SUBJECT: Response to RAI dated July 12, 2010
Re: Request for Amendment of US Nuclear Regulatory Commission
Certificate of Compliance No. 9204 for the Model 10-160B Shipping
Cask, E&L-037-10, 2 April, 2010
Docket No. 71-9204
TAC No. L24435

Response to Request for Additional Information on 10-160B

CONSOLIDATED SAFETY ANALYSIS REPORT

MODEL 10-160B

Figure 5.3 Maximum Activity for Point and Unit Density Distributed Sources

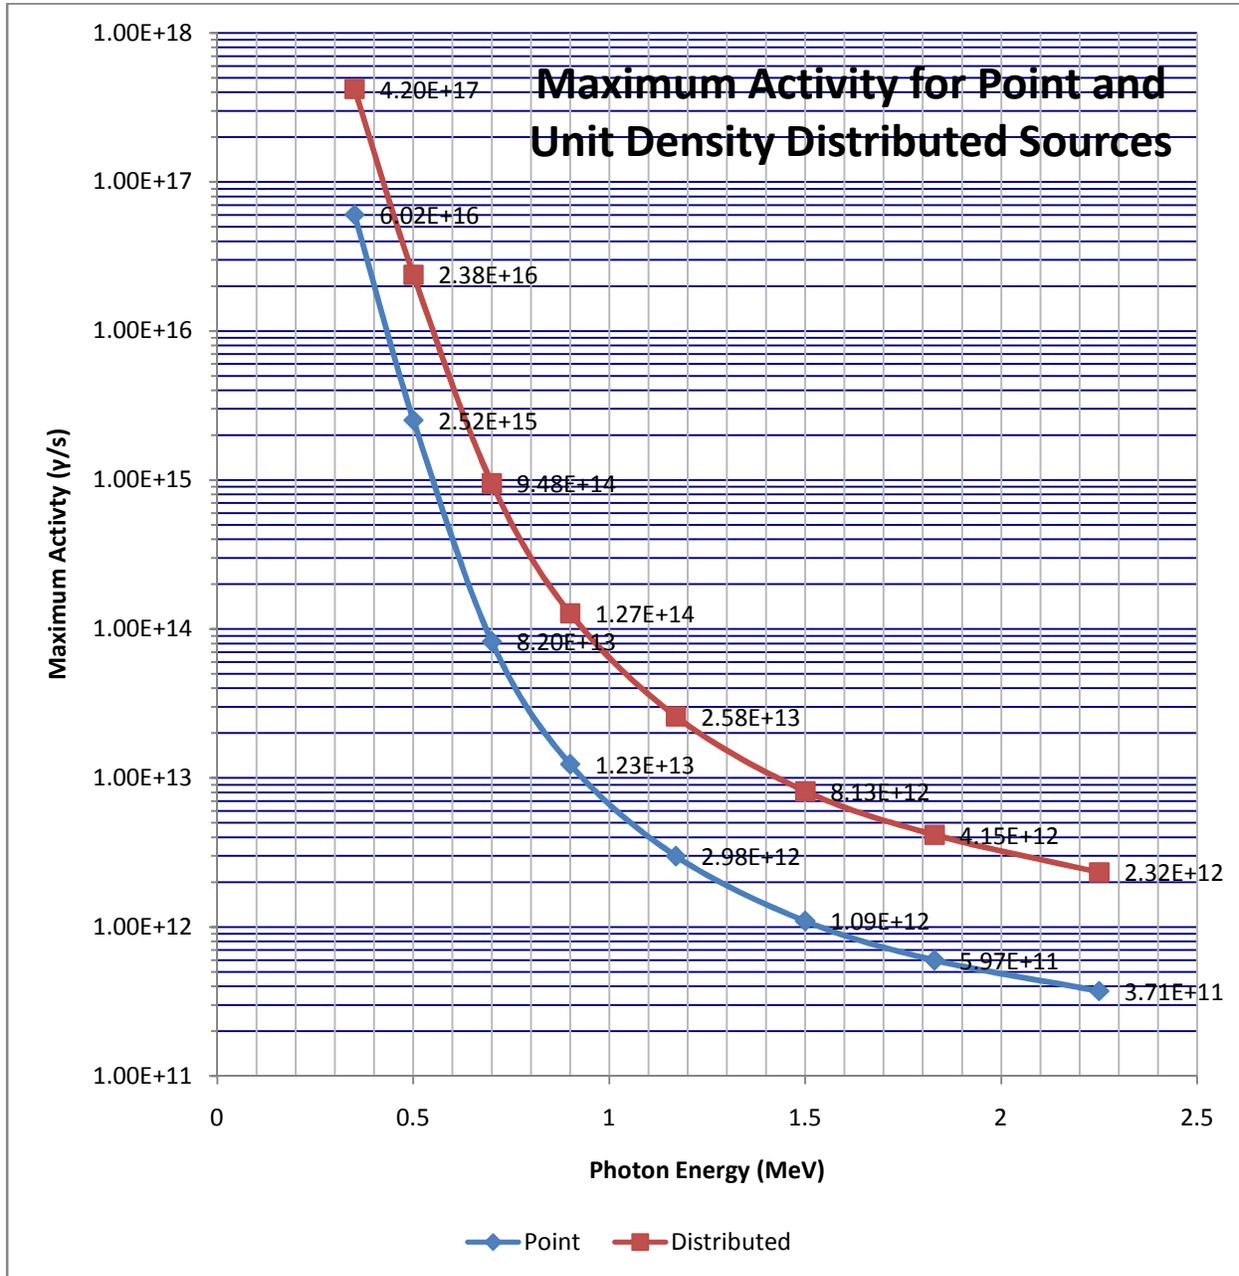
RAI 5-2 Provide the maximum allowable content based on calculated values for allowable external doses.

There is no analysis described in the Consolidated SAR, Rev. 1, where the applicant explains or gives details regarding the calculated dose limits. The applicant can either provide an allowable activity limit for each isotope for NCT or

Staff indicated the need for an additional parameter, which would complement the current $3000A_2$ and 100 watts limits, to provide a boundary for higher energy gamma emitting contents in the Certificate of Compliance contents description.

Chapter 5 has been revised to include bounding values for the source term in terms of gammas/sec and MeV/gamma. A restriction has been added to Chapter 1 and a procedure for implementing this limit has been added to Chapter 7. These revisions are attached for review.

The cask activity limits for a point source and a unit density distributed source are plotted in Figure 5.3.
